# SWAG 10 92 6775

to fit:  
Mercedes Benz CDI engines

Repl. No. 646 200 05 70

## Belt tensioner

SWAG no. 10 92 6775  
ref. no. 646 200 05 70

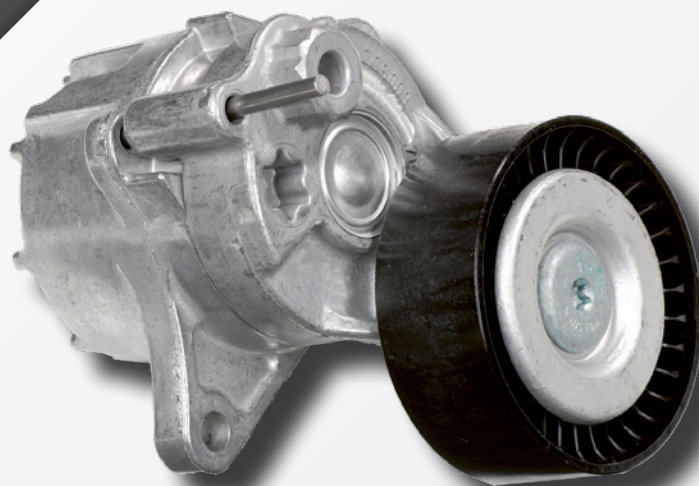
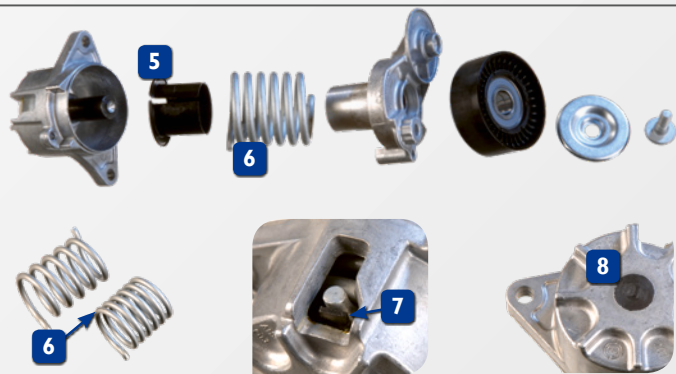
For design reasons, when the vehicle is driven with the original version of the belt tensioner installed (ref. no. 611 200 04 70), noise may occur (The manufacturer has now replaced this version).

The noise is generated because the spring is too long and makes direct contact with the base of the housing (1). Only the spring's torsional characteristics are important for this application (2), (6).

The noise is caused when the spring touches the cast-in hollow pin (3) and the base of the housing (4).

A highly wear-resistant plastic bushing (5) distance the spring from the base of the housing and prevents metal-to-metal contact where the spring is located. Since only the springs' torsional characteristics are important the height has been reduced (6).

The spring makes contact with the plastic bushing (7) and is therefore prevented from touching the base of the housing. No noise can therefore occur. In the new version (8), a steel pin has been cast in the base of the housing in order to center the spring.
